Proposed Revisions to a Standard Plans Index  
(Please provide all information — Incomplete forms will be returned)

Index Number: 649-020  
Sheet Number (s): 3 of 6  
Index Title: STEEL CCTV POLE

STEEL CCTV POLE

INDEX  
649-020

SECTION A-A

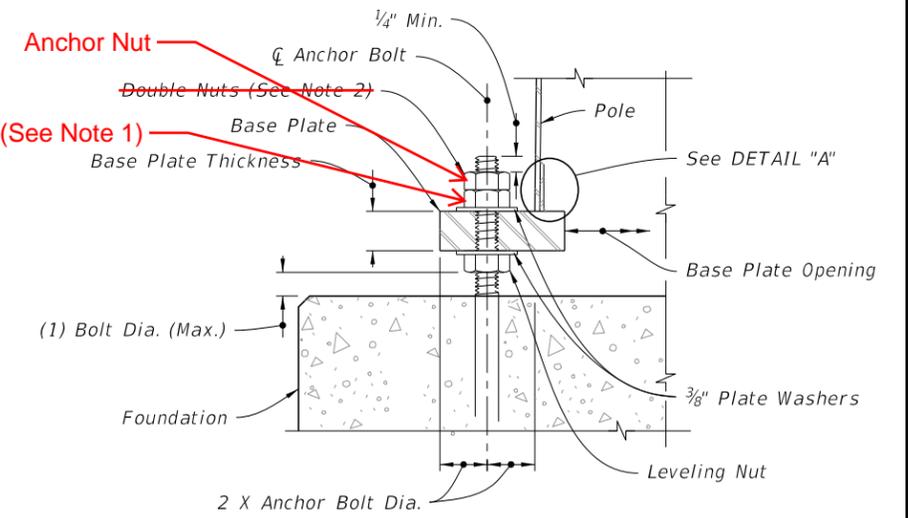
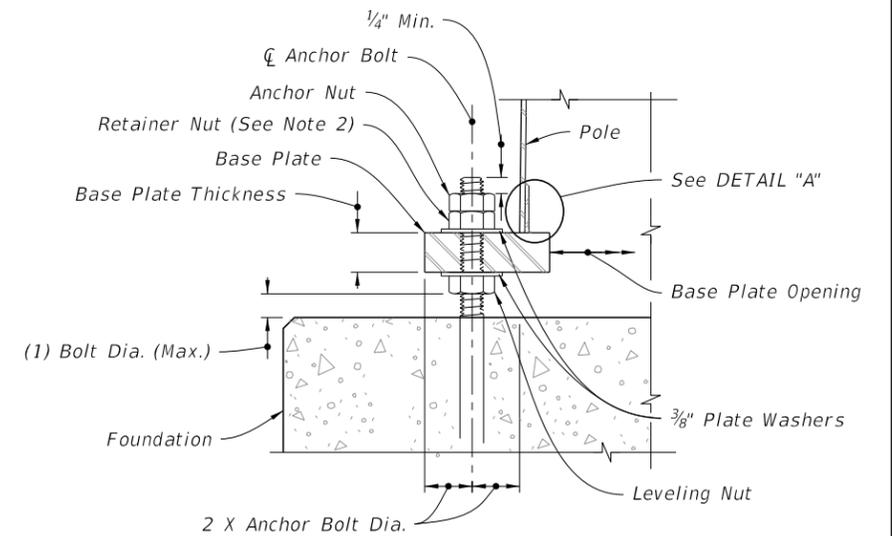
Sheet 3: Changed Note 2 and revised Section A-A to add clarity to anchor bolt nuts.

Sheet 3: These changes were to add clarity, consistency, and specificity to the anchor bolt nuts.
